Section 6.0 | Responses to Comments

6.1 INTRODUCTION

The Draft EIR was submitted to the State Clearinghouse Office of Planning and Research and circulated for public review from October 17, 2022 to January 17, 2023.

Figure 1: Traffic simulation results by the hour

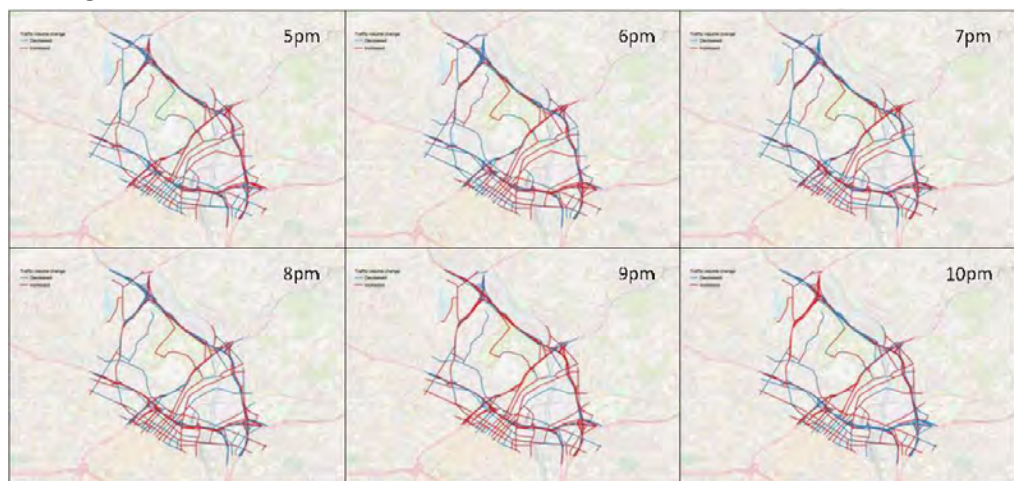
Comment ML-3 Findings

- Contrary to claims from LA ART, researchers found that the gondola would not significantly reduce traffic around Dodger Stadium.** Results showed the gondola would likely slightly reduce traffic on some roads around the stadium for a sold-out night game and increase traffic on others, leading to little reduction in greenhouse gas emissions. The red lines in Figure 1 above indicate road segments that have a higher traffic volume after the proposed gondola is added to the traffic simulation. The blue lines indicate a decrease in traffic volume. According to the simulation, the total traffic volume would likely be reduced by around 0.9%

The graphic presented in Figure 1 of the Mobility Lab Study illustrates preliminary traffic simulation results from the Mobility Lab’s model for the highway system in the vicinity of Dodger Stadium. The transportation model roadway network shown in Figure 1, however, shows that the Mobility Lab Study and model network is missing many of the critical roadways that link to Dodger Stadium (including Stadium Way, Vin Scully Avenue, Chavez Ravine Place, College Street, Bishops Road, the SR-110 ramps to/from the Dodger Stadium Downtown Gate, and the Dodger Stadium gates themselves). This is typical for regional travel demand models designed for analysis of the regional transportation system, which by design do not include smaller subregional streets or event venues. However, the missing streets play an important role in access to/from the stadium. A more sophisticated localized analysis of traffic increases and decreases in the vicinity of Dodger Stadium should include customization of the model’s highway network to include an increased granularity of detail for the streets serving the stadium, as this network has a profound effect on congestion in the neighborhoods surrounding the stadium. The lack of roadway network customization in the Mobility Lab Study model to include the key roadways serving Dodger Stadium underreports the benefits of trip reductions around Dodger Stadium, because the roadways that access the Stadium are those where the full benefit of the proposed Project would be experienced. The omissions of these roadways from the Mobility Lab Study model renders any estimation of traffic reductions and/or increases to be incomplete and aligns with the Mobility Lab’s own statement that their forecast for the proposed Project should be considered preliminary.

Figure 1: Traffic simulation results by the hour

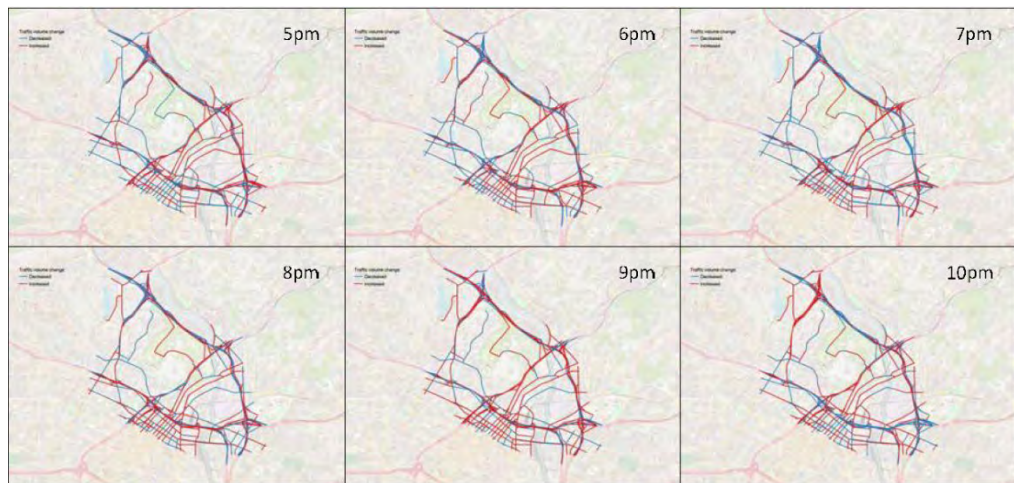
Comment GO24-14

- Contrary to claims from LA ART, researchers found that the gondola would not significantly reduce traffic around Dodger Stadium. Results showed the gondola would likely slightly reduce traffic on some roads around the stadium for a sold-out night game and increase traffic on others, leading to little reduction in greenhouse gas emissions. The red lines in Figure 1 above indicate road segments that have a higher traffic volume after the proposed gondola is added to the traffic simulation. The blue lines indicate a decrease in traffic volume. According to the simulation, the total traffic volume would likely be reduced by around 0.9% (less than 1%) on the roads surrounding the stadium if the proposed gondola is built.

Response GO24-13 Refer to Response ML-2 in Topical Response O, Response to UCLA Mobility Lab Study.

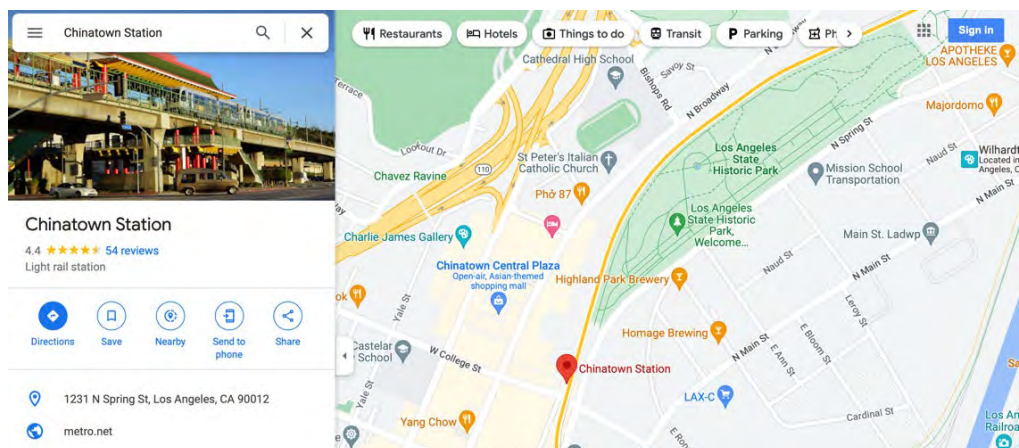
This means that at least 1,850 of Project riders on game day are likely to be users diverted from the existing free bus Shuttle, and thus do not count as a reduction in VMT. The number of actual new and diverted game day riders will be a function of fare, which has not been disclosed in the DEIR. At maximum, 3,250 Project users in 2026, increasing to 6,650 users in 2042 would thus be ticket holders either diverted from other transit or newly using transit to access the Stadium on game day. Given the post-game loading time for the Project of up to approximately 1 hour 12 minutes in 2026 increasing to 2 hours in 2042 given projected ridership, it is unclear how many ticket holders will want to use this private gondola system, which requires access via Union Station, and which will likely charge a fare in order to maintain the system.²³

Should game day ticket holders choose to make use of the Project, it is unclear how much of a VMT reduction will actually occur, as it would depend on both how, and from how far away, users come to access the system.

Image from DEIR Appendix C – Visual Impact Analysis / Lighting Design

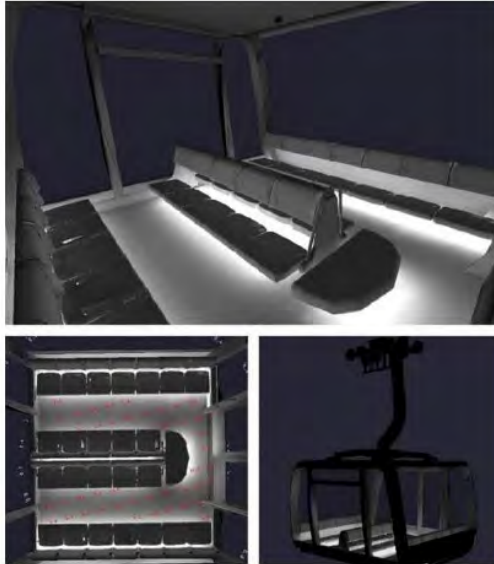
Comment P702-41

There needs to be greater consideration for security of the gondola infrastructure to prevent unintended uses of the system. If the opening of the Sixth Street Viaduct is any indication, the absence of ladders will not prevent people from climbing the towers and stations. If a person is able to get access to the Dodger Stadium parking lot or the Broadway Junction, would they be able to use The Gondola as a zip line?

DEIR Image – Road Closures at Broadway Junction during Construction

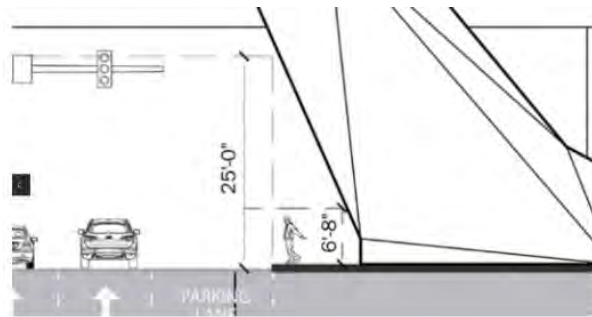
Comment P702-87 “For multi-level stations, a strategy to change heavy machinery and parts (i.e. gearboxes, motors and etc.) will be required in case parts are broken. For instance, if a station is 4 storeys high, project proponents must design and have strategies in place to remove and deliver machinery.”

Response P702-87 Refer to Response P702-69 for discussion of how lane closures associated with maintenance activities would be temporary and how maintenance activities would not necessitate the same road closures as those necessary for the construction of the proposed Project. This comment includes an image from Appendix B, Construction Assumptions, of the Draft EIR, which depicts the Deck Removal phase of construction of the Broadway Junction. This phase of construction would be three weeks. As discussed in Section 3.17, Transportation, and Appendix B, Construction Assumptions, of the Draft EIR, most to all lanes would remain open during the other phases of construction of the Broadway Junction, including Foundations and Columns (28 weeks), Structural Steel and Gondola Equipment Erection (38 weeks), and Vertical Circulation / Hardscape and Landscape / Interior Work (29 weeks).

DEIR Image of Broadway Junction with Notes

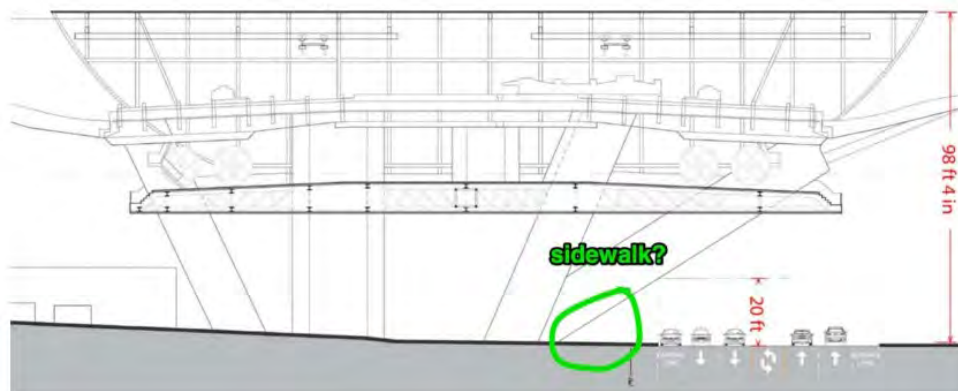
Comment P702-89 Broadway Junction: More information is needed on the sidewalks around the Broadway Junction, especially at the area indicated in the image below. How high is the overhead clearance of the support column, how wide is the usable space of the sidewalk? There is a bust stop located at this location on Broadway. Will this interfere with a bust stop shelter? How wide will the sidewalk be along Bishop's Road? Currently, there is no sidewalk, even though it is an official route to Dodger Stadium.

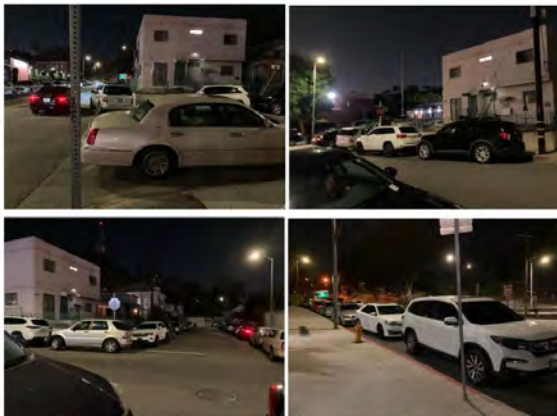
Comment P702-92 Union Station Parking Count: Spaces reserved for Metro Emergency Vehicles, Facilities Maintenance, Maintenance Carts, Metro Board and Staff, 10 Minute Waiting Zones, Childcare pickup and drop off, and other reserved uses appear to have been

counted as available parking for gondola customers. We ask for an accurate count of available parking that does not include spaces reserved for other uses.
